**IFB #2023-39**

**Northview Midrise Underground Water Storage Tank**

**ADDENDUM NO. #2**

**Sheet No. C552**

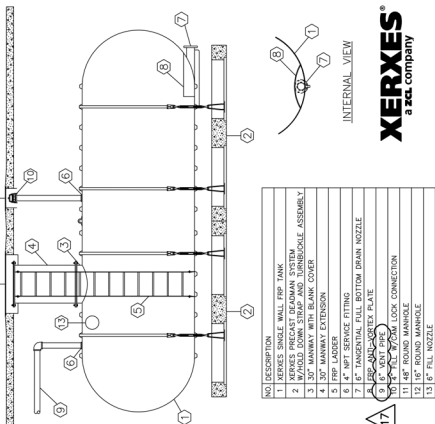
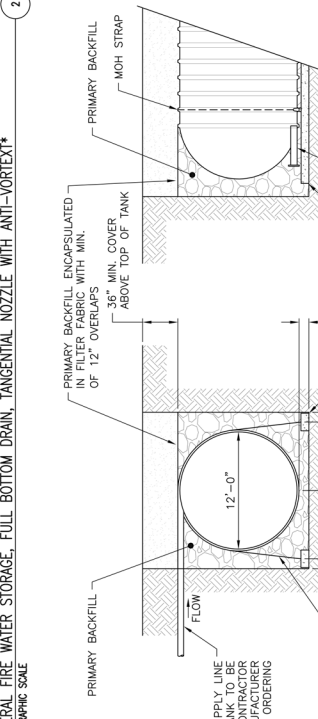
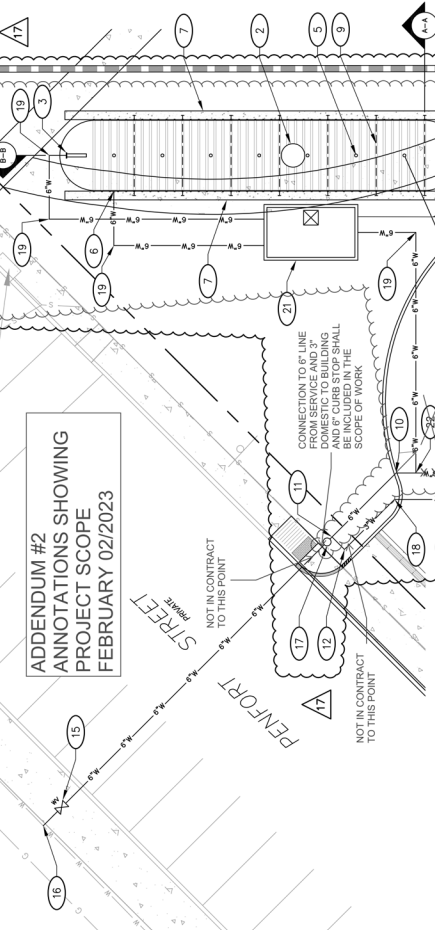
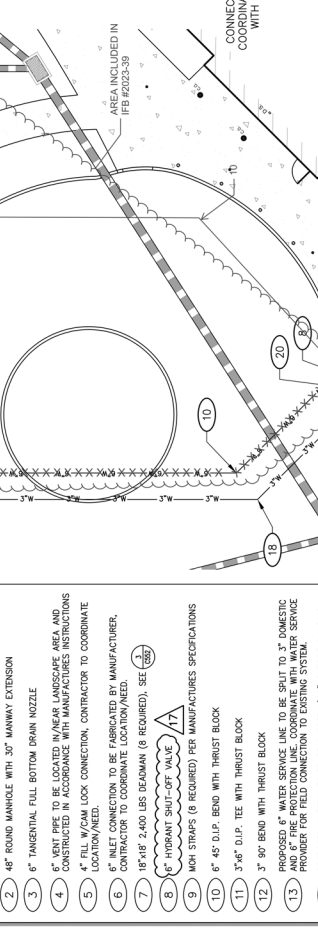
**Item 4: Routing and configuration for the fire tank filler and the building fire service has been modified. See attached annotated drawings C552 Labeled “ADDENDUM #2 ANNOTATIONS SHOWING PROJECT SCOPE FEBRUARY 02/2023” and C554 “ADDENDUM #2 UPDATED FIRE SERVICE VAULT FEBRUARY 02/2023”**

**A: Annotated drawings C552 have been attached to this addendum. See also the answer to Item 1.**
